Colstrip Steam Electric Station Units 3&4 Coal Ash Ponds

Units 3&4 Remedy Evaluation Overview

February 2020

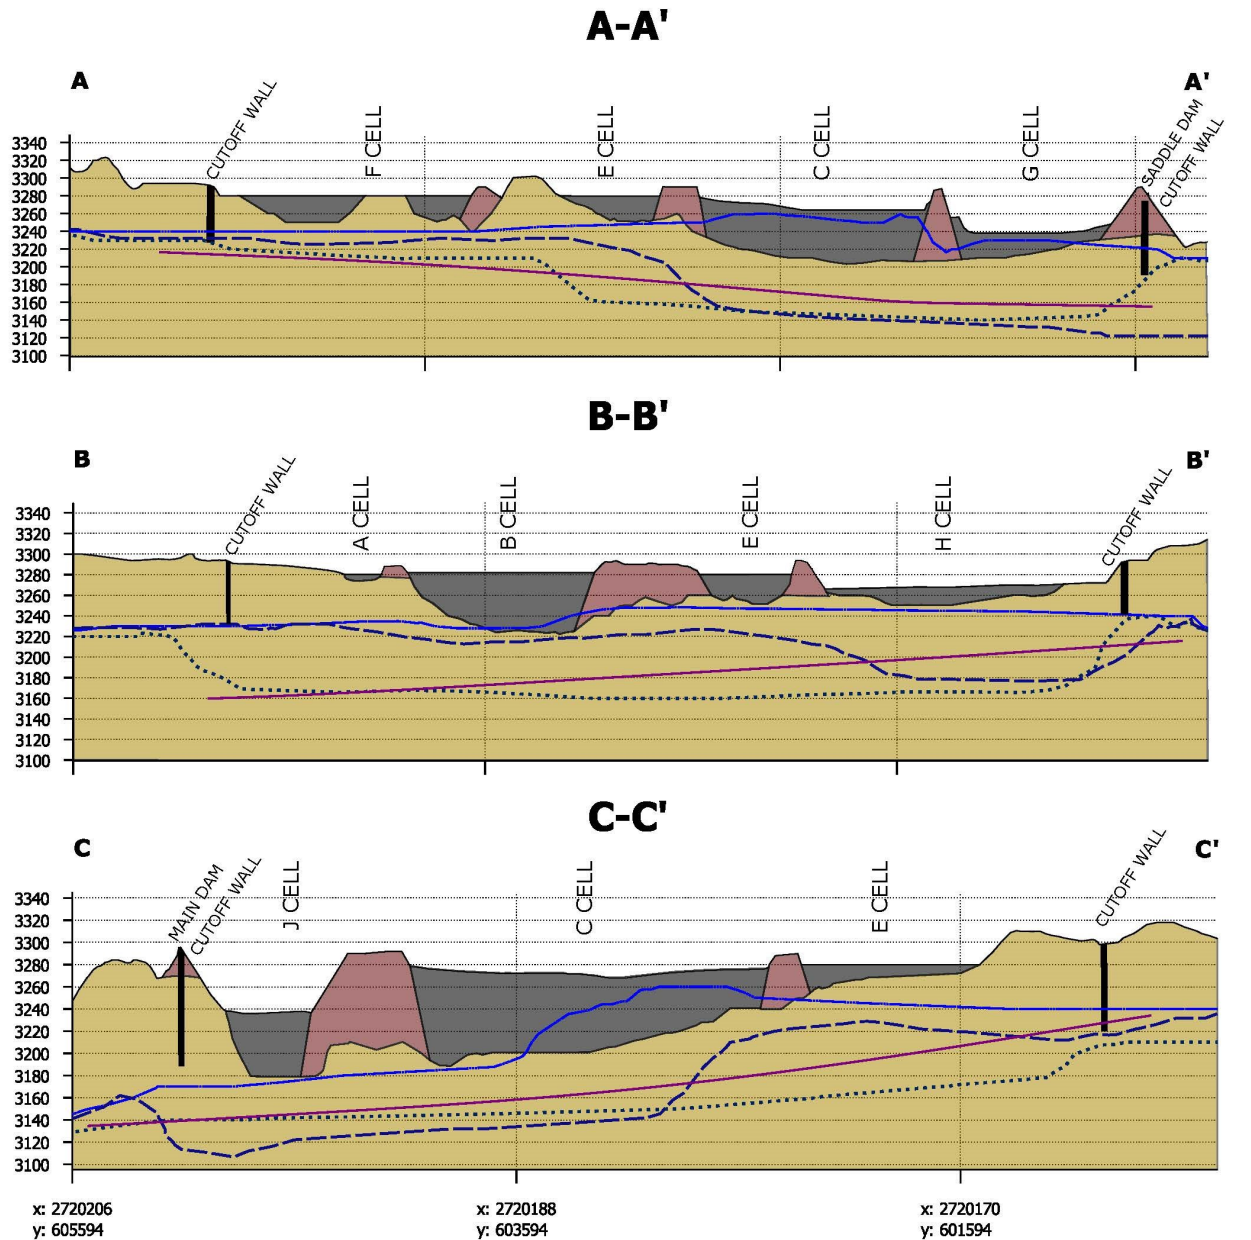
Talen provided the figure below showing the elevation of the water table relative to the bottom of the ponds in 2020 (current), 2040 (during pumping) and 2070 (20 years after pumping ceases). Although the ponds are currently within the water table, modeling shows the water table will drop below the base of the ponds once they are dewatered and capped.

* 2020 water levels are the result of saturated ash that will be dewatered as part of the remedy

* The 2040 water table is higher than the 2070 water table in most locations due to active fresh water injection for flushing. The 2040 water table is lower than the 2070 water table in a few locations due to active extraction.

* The CCR rule upper most aquifer is an interpolated surface based on eight historical water levels from pre-pond construction
